MD Helicopters, LLC

***MD500/600 Series
Technical Bulletins Package***

This package contains a complete set of
all Technical Bulletins issued through:

22 August 2023

Figure 1. Rework of One-Way Lock Assembly

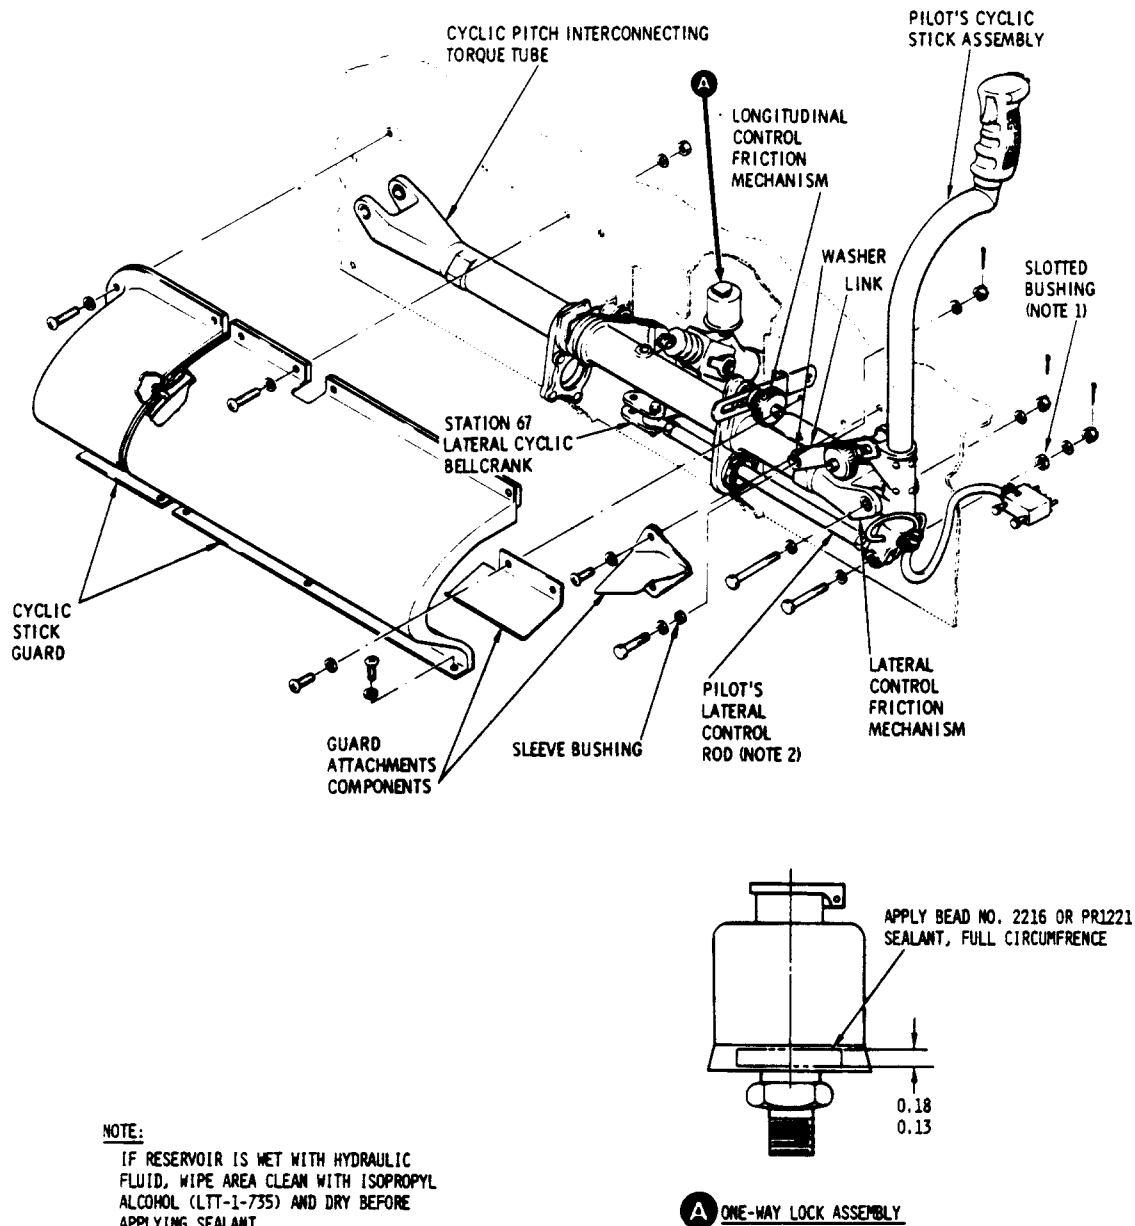
- a. Remove one-way lock from helicopter. (Refer to Section 7 of Basic HMI-Vol 1.)
- b. Prepare No. 2216 or PR1221 class B per manufacturer's instructions.
- c. Using extrusion gun or spatula, apply 0.18/0.13-inch bead of sealant full circumference between base of reservoir and bowl flange and dry per manufacturer's instructions.
(See Figure 1.)

Figure 2. Drain Kit Installation - PN 369D290120 Transmission Oil Cooler (Sheet 1 of 2)

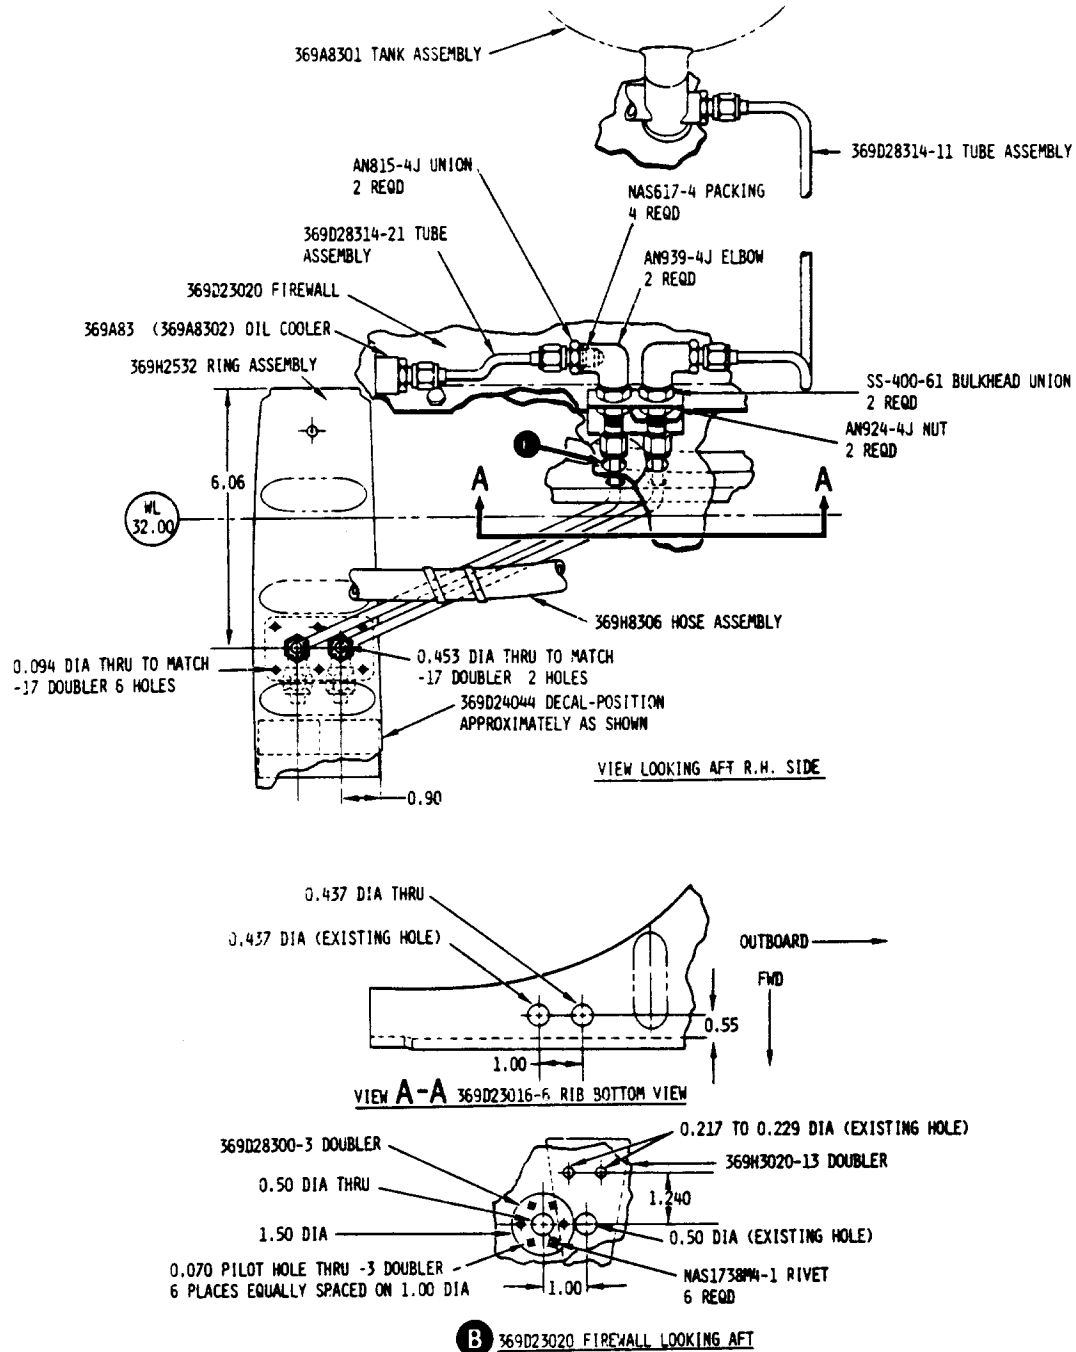
b. Drill 0.453 inch diameter hole in LH side of 369H2532 ring assembly at dimensions shown in Figure 2. Install AN833-4J elbow with AN960-C716 washers and AN924-4J nut.

Figure 1. Rework of Static Pressure Tube Installation

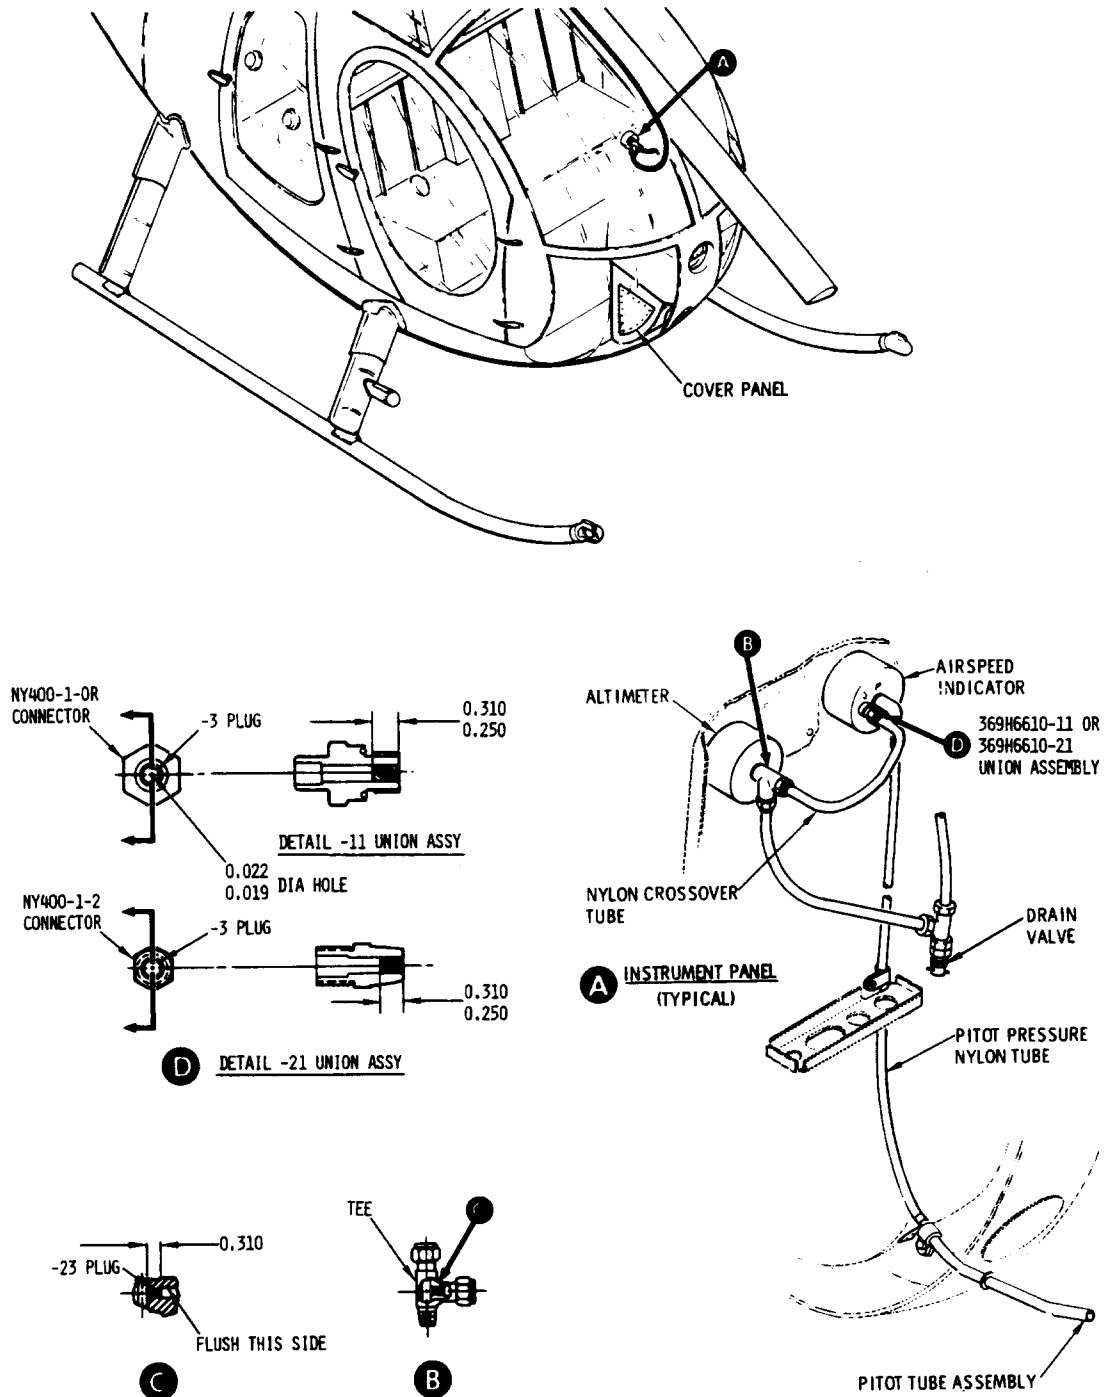
- (1). Check that all electrical power is OFF.
- (2). Remove instrument panel fairing and hood, per HMI-Vol I.
- (3). Disconnect drain tube from 369H6628 tee at altimeter indicator. (See Figure 1.)
- (4). Press fit new 369H6610-23 plug into tee as show, reconnect drain tube to tee. (See View B.)
- (5). Disconnect crossover tube from connector at airspeed indicator.
- (6). Remove existing -3 plug from 369H6610-11 or -21 union assembly,
- (7). Reconnect crossover tube to connector at airspeed indicator.
- (8). Reinstall instrument panel fairing and hood.
- (9). Perform flight test to check instrument operation.

Figure 1. Relocation of Auto Reignition Controls (Sheet 2 of 2)

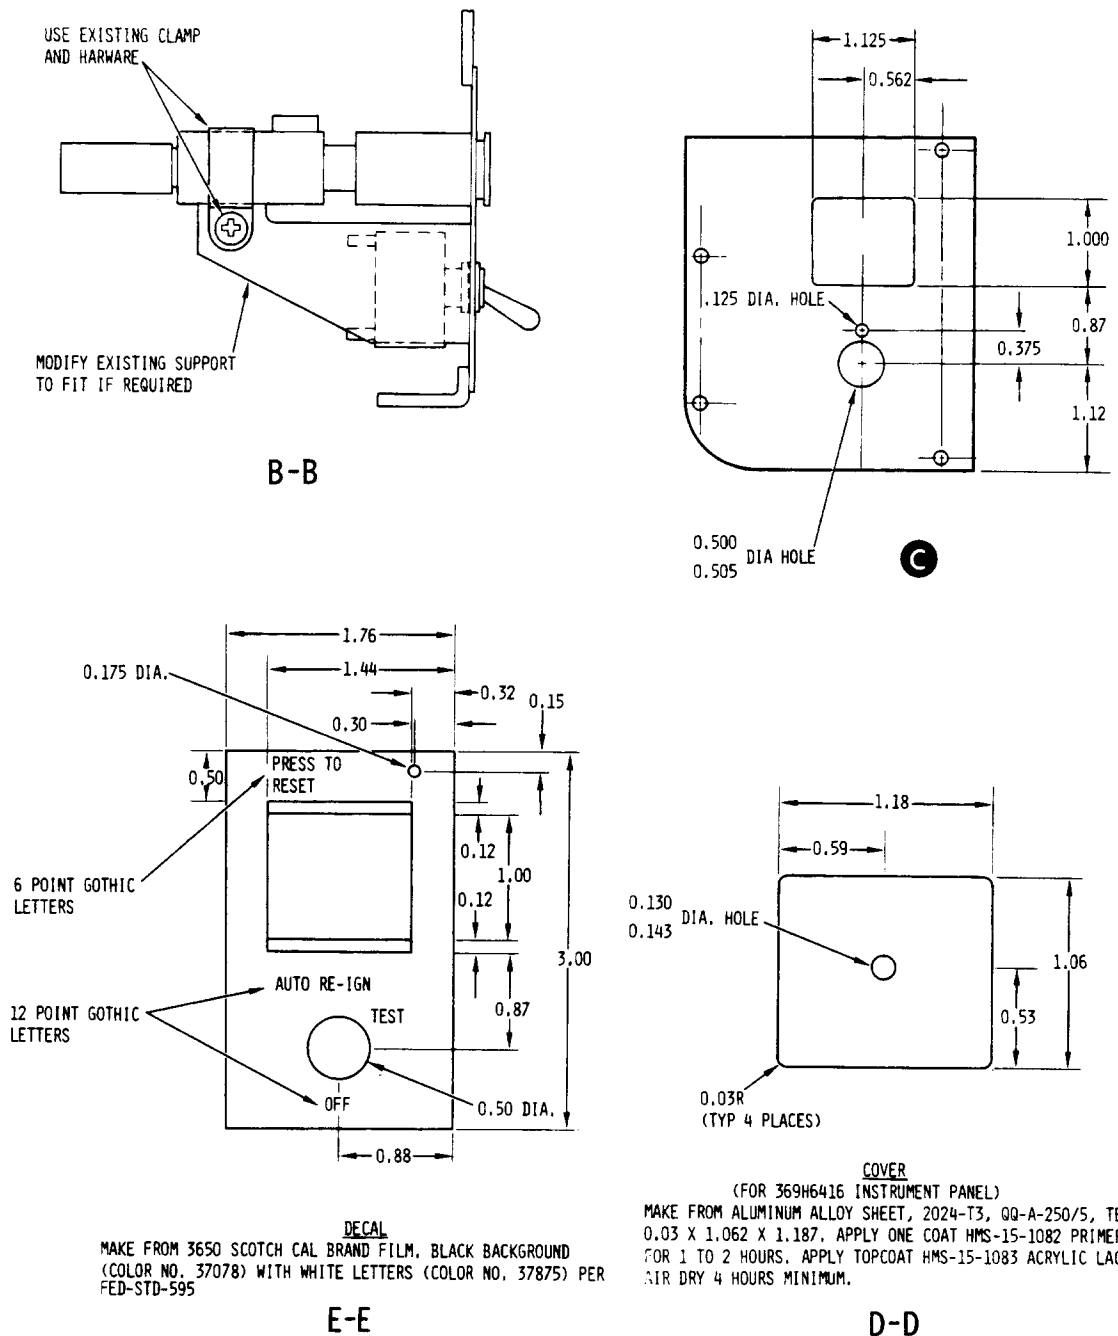
- (3). Remove relays (K304 and K104) and switch (XDS9) from ship. Remove all wires from relays and switch and retain relays and switch for reuse.
- (4). Fabricate cover, as required, for hole vacated by switch (see Figure 1).

- (5). Install cover on instrument panel (see Figure 1).
- (6). Install plug button on instrument panel (see Figure 1).

- (7). Paint out lettering at previous auto reignition switch location with acrylic lacquer.
- (8). Fabricate plate, as required:
 - (a). Make plate from 0.062 inch thick aluminum alloy sheet as shown in Figure 1.

- (b). Apply one coat HMS-15-1082 primer and dry for 1 to 2 hours.
 - (c). Apply topcoat of HMS-15-1083 acrylic lacquer and air dry 4 hours minimum.
- (9). Install plate and auto reignition switches (XDS9) (retained above) and (S11) (PN 882GK15, Cutler Hammer or equivalent) at new location on instrument panel (see Figure 1).

Figure 2. Wiring Diagram

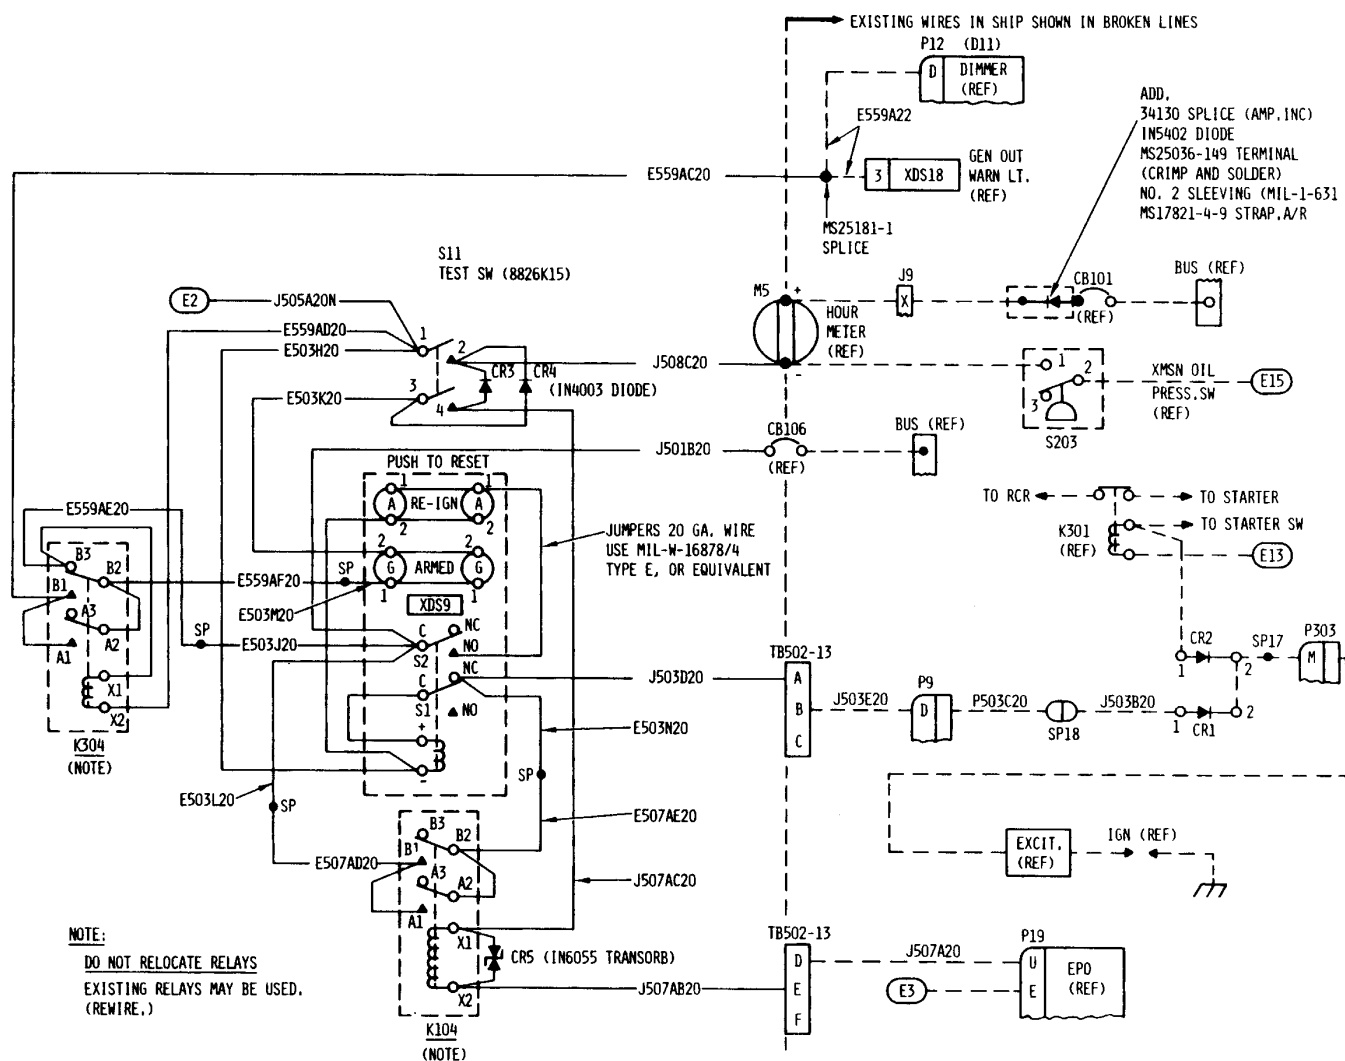
- (10). Fabricate and install decal on instrument panel (see Figure 1).
- (11). Revise wiring as follows (see Figure 2):
 - (a). Install diode at circuit breaker (CB101),

Figure 1. Check Valve Installation

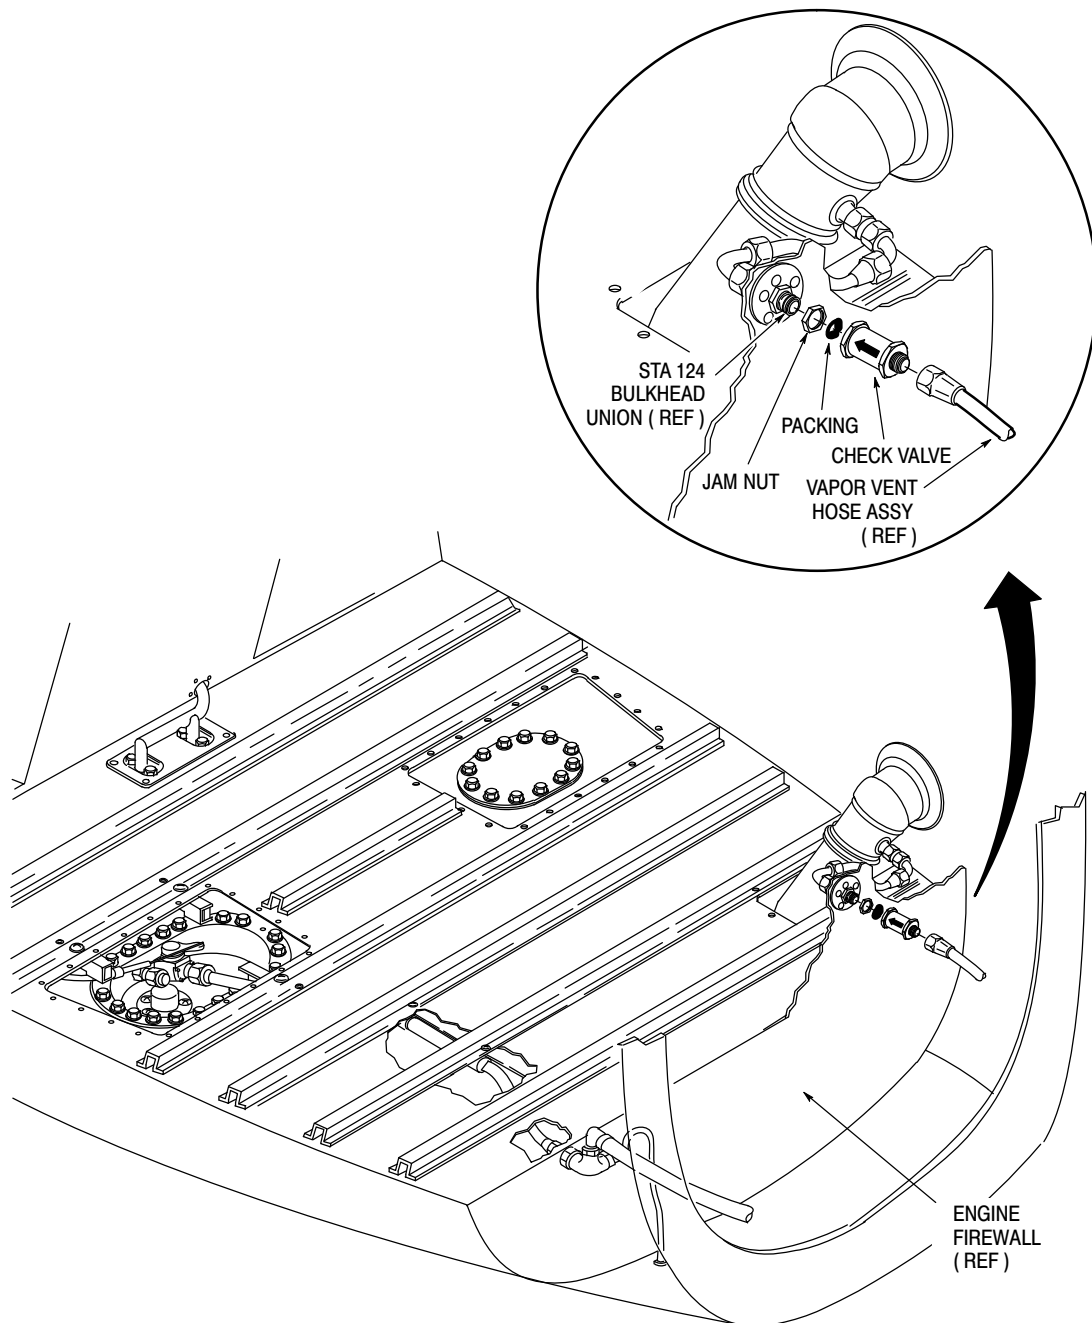
- (1). Open engine access doors.
- (2). Disconnect vapor vent hose assembly from Sta 124 bulkhead union.
- (3). Thread AN924-4 jam nut on bulkhead union
- (4). Install MS29512-04 packing on bulkhead union.
- (5). Thread 859T-4TB check valve on bulkhead union with arrow on check valve pointing toward union. Torque AN924-4 jam nut to **135-150 in lb (15.61-17.33 N•m)**.
- (6). Connect vapor vent hose assembly to check valve. Torque hose assembly nut to **135-150 in lb (15.61-17.33 N•m)**
- (7). Close engine access doors.

Figure 1. Structural Modifications

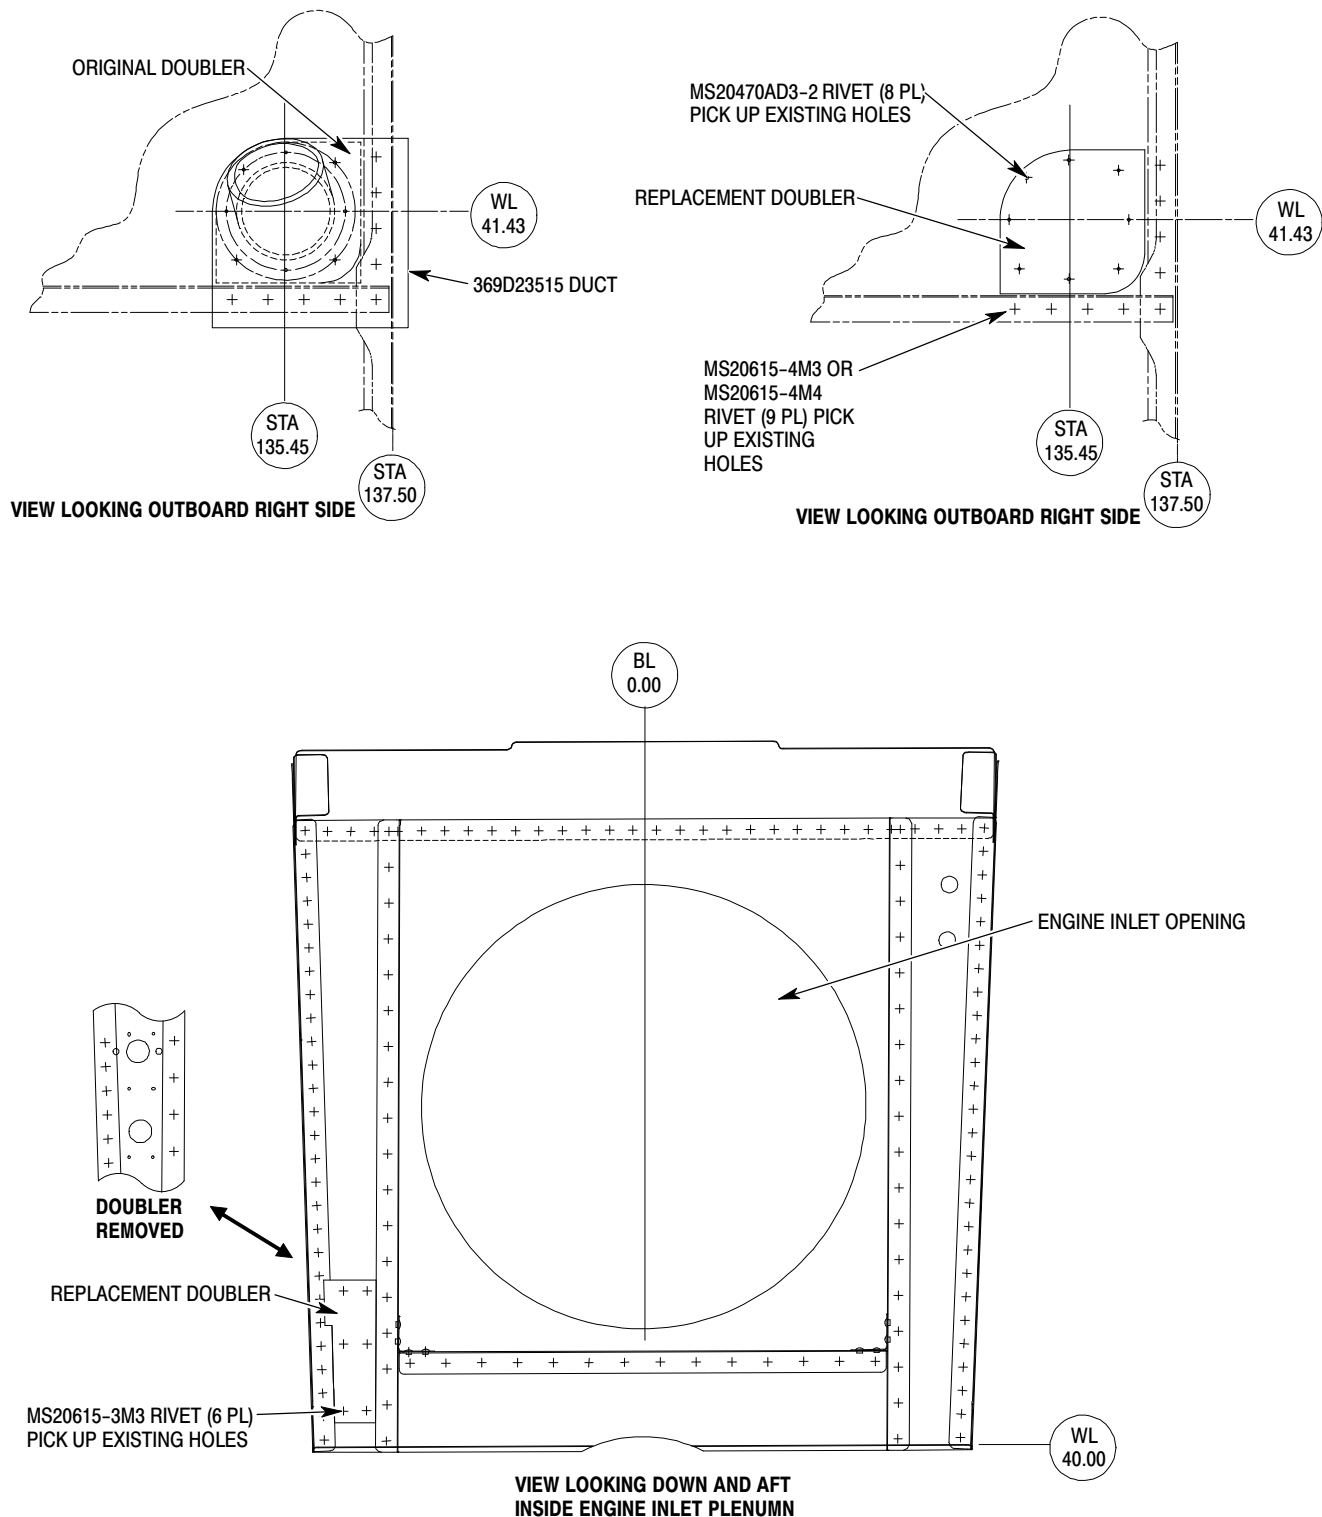
- (3). Doubler replacement method:
 - (a). Remove existing T1 doubler from plenum wall.
 - 1). Remove six (6) MS20615-3M rivets with a number forty (40) drill bit.
